**STAFF REPORT  
KETCHUM PLANNING AND ZONING COMMISSION  
MEETING OF NOVEMBER 9, 2021**

**PROJECT:** 380 N 1<sup>st</sup> Ave Mixed-Use Building

**FILE NUMBERS:** P21-085

**APPLICATION:** Design Review

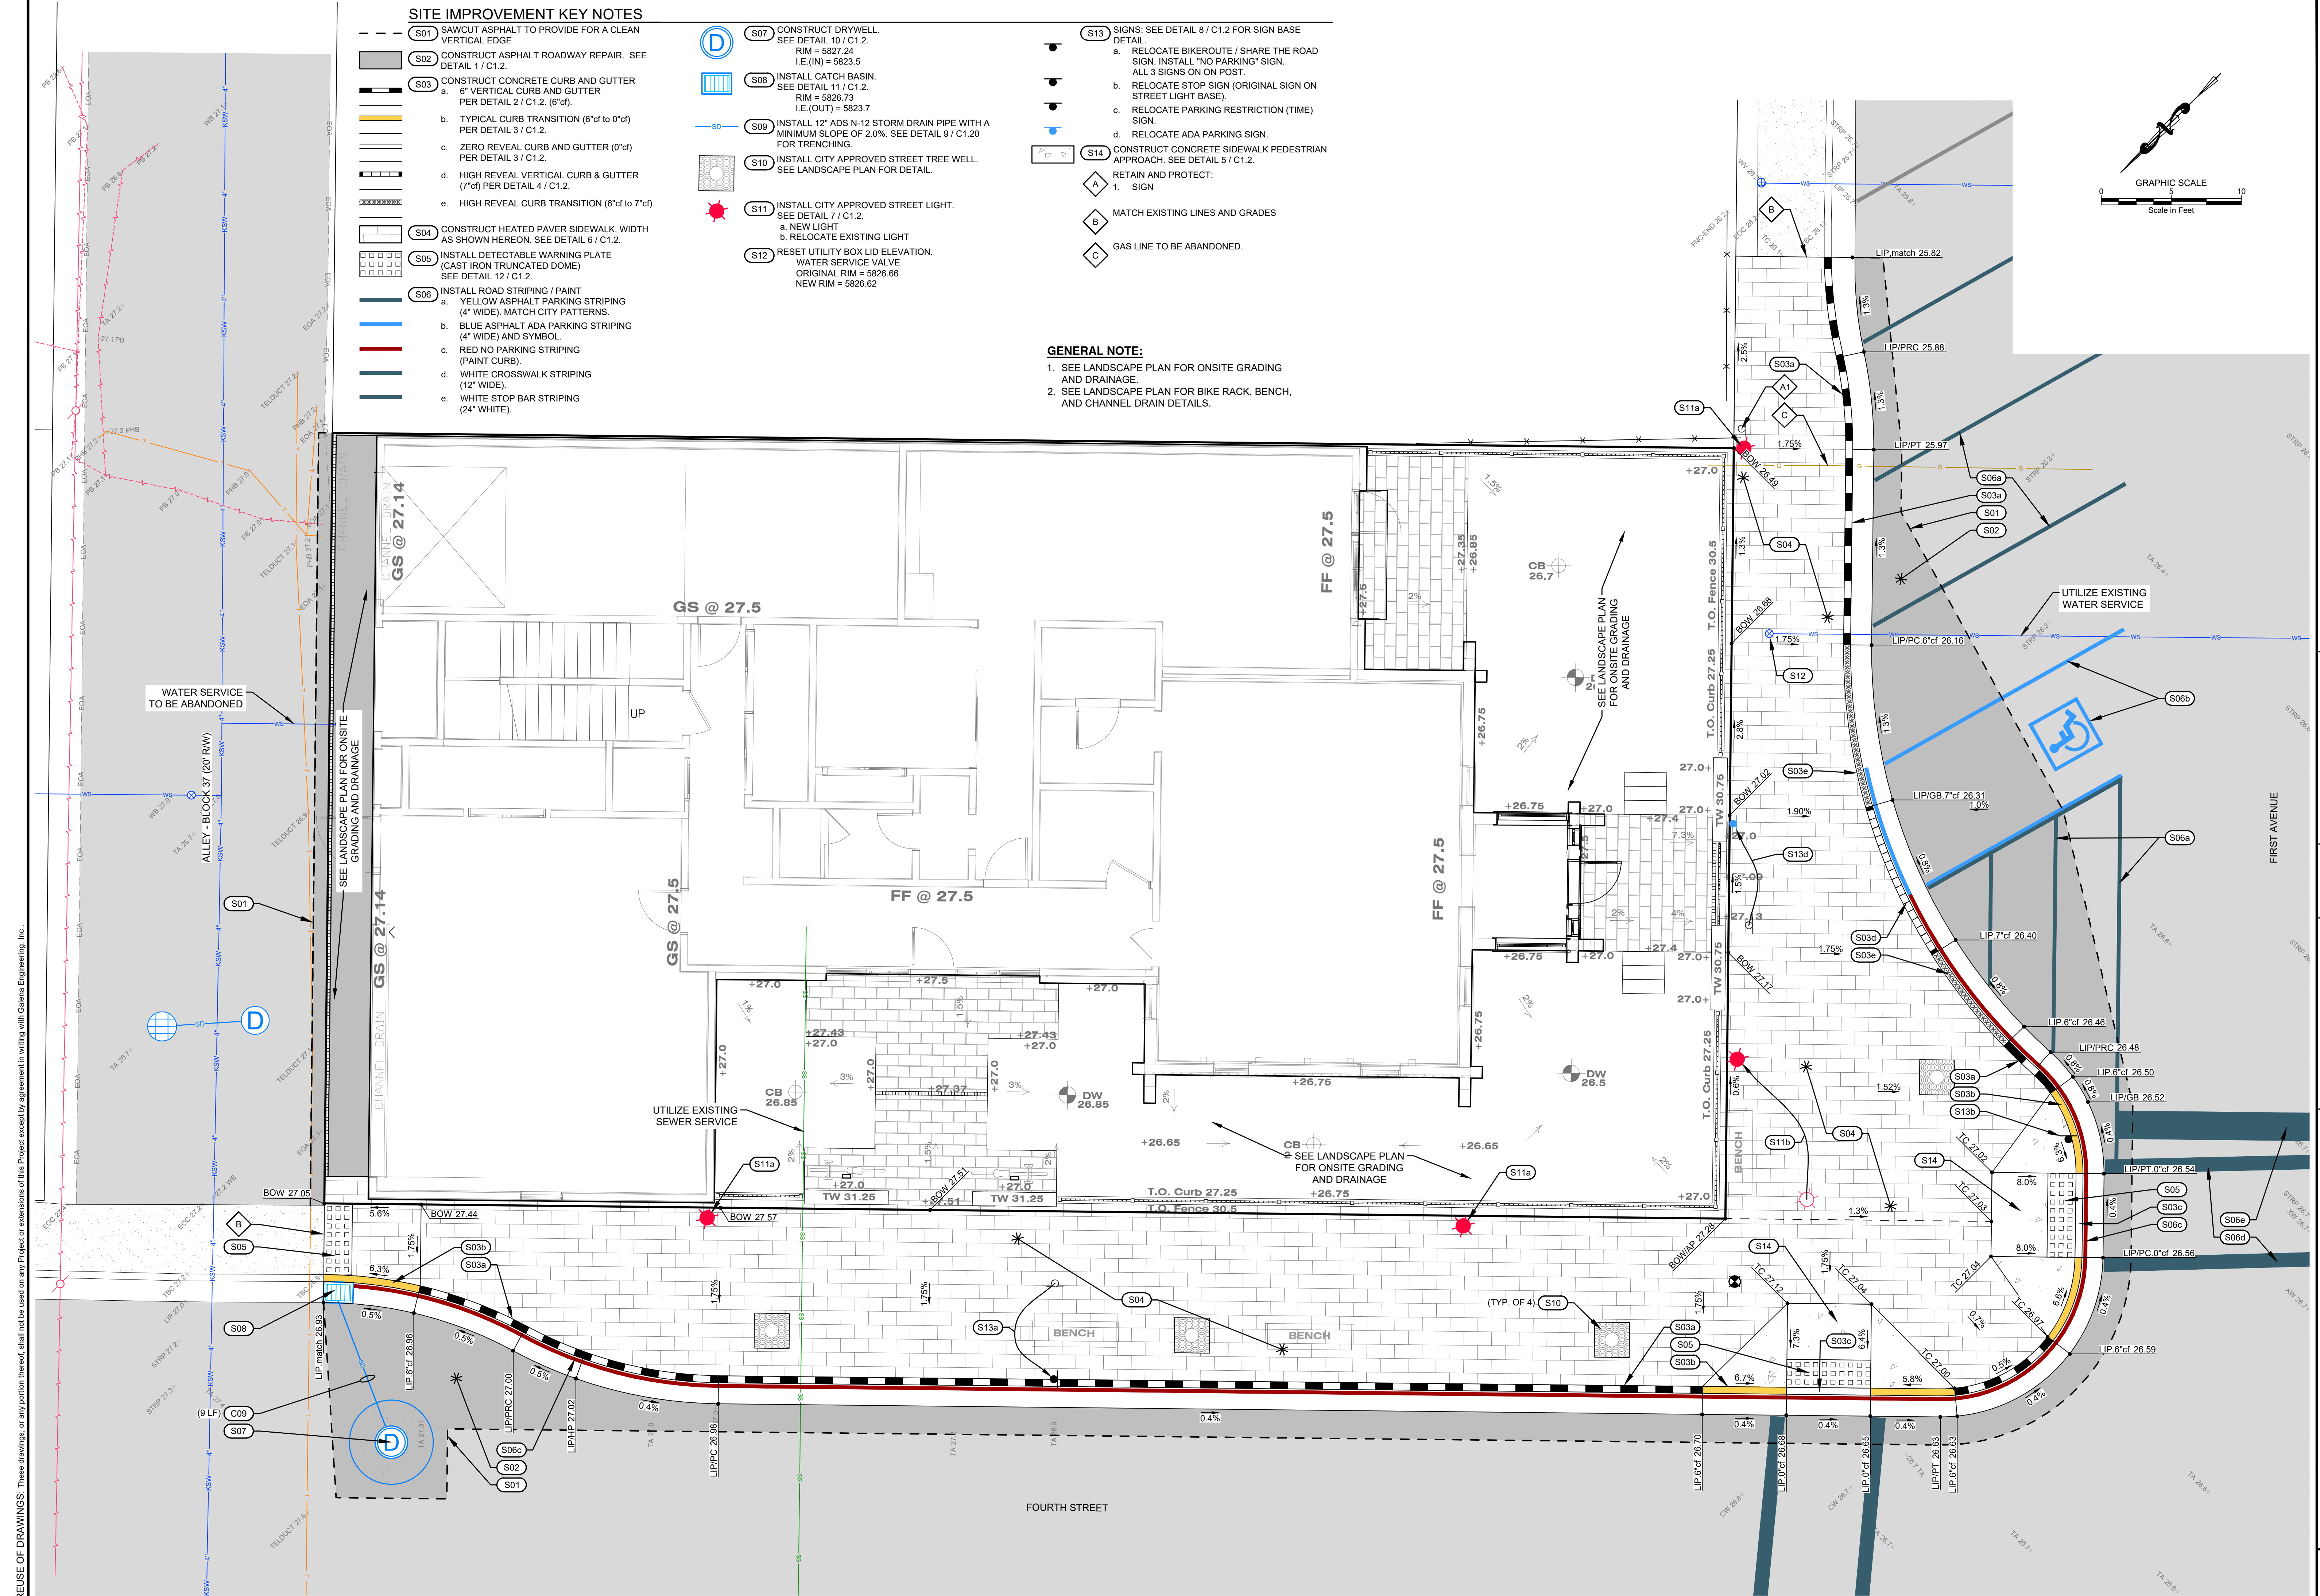
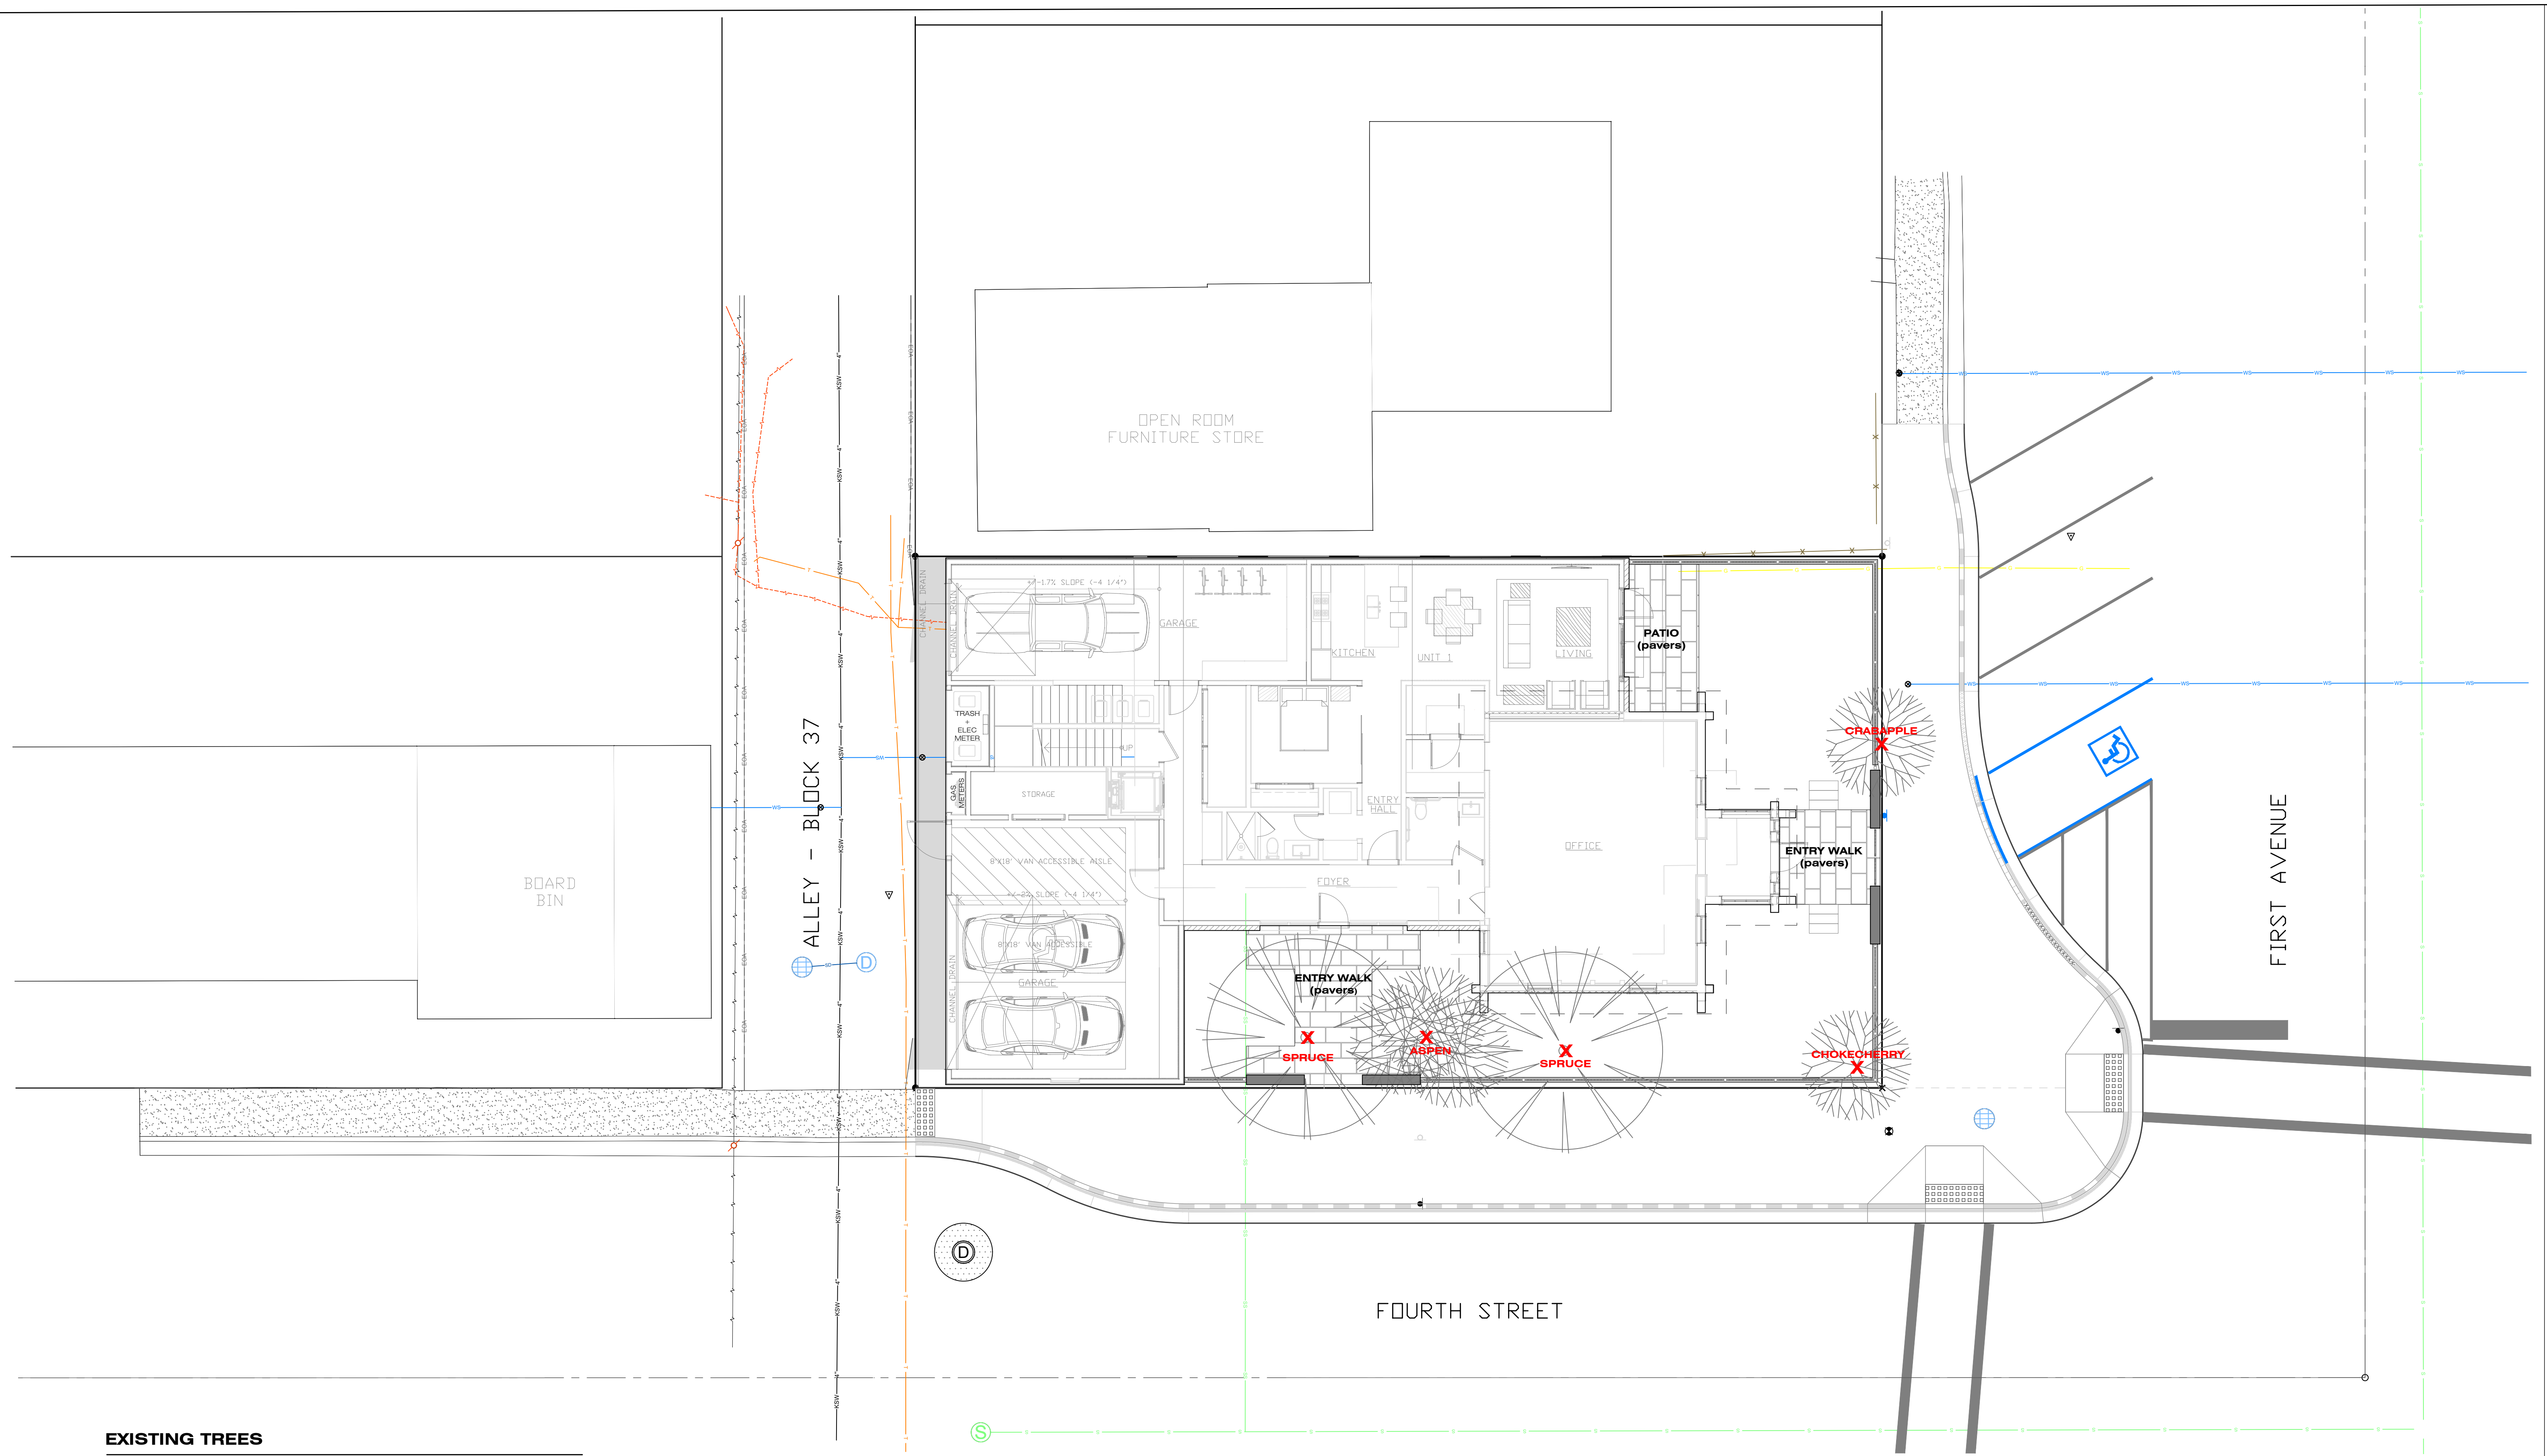
Staff Comments	The applicant has proposed to install new heated, paver sidewalks along 4 <sup>th</sup> Street and 1 <sup>st</sup> Avenue (Project Plans: Sheets C1.1 and C.12).  Final civil drawings for all associated ROW improvements shall be submitted with the building permit application to be verified, reviewed, and approved by the City Engineer and Streets Department.
<input checked="" type="checkbox"/>	<input type="checkbox"/>	<input type="checkbox"/>	17.96.060.B2 Sidewalks	Sidewalk width shall conform to the City’s right-of-way standards, however the City Engineer may reduce or increase the sidewalk width and design standard requirements at their discretion.
			Staff Comments	The applicant will install new heated, paver sidewalks along both 1 <sup>st</sup> Avenue and 4 <sup>th</sup> Street.  Final civil drawings for all associated ROW improvements shall be submitted with the building permit application to be verified, reviewed, and approved by the City Engineer and Streets Department.  <u>Applicant’s Design Review Standards Evaluation Comments</u> <i>The sidewalk along Fourth Street is proposed to be 12’ wide to meet the Fourth Street Pedestrian Corridor Standards, which match the project under construction at the southwest corner of 1st and 4th. The sidewalk along First Avenue is proposed to be 8’ wide to meet City Street Standards. A bulb-out at First Avenue also mimics the bulb-out designed for the project under construction to the west.</i>
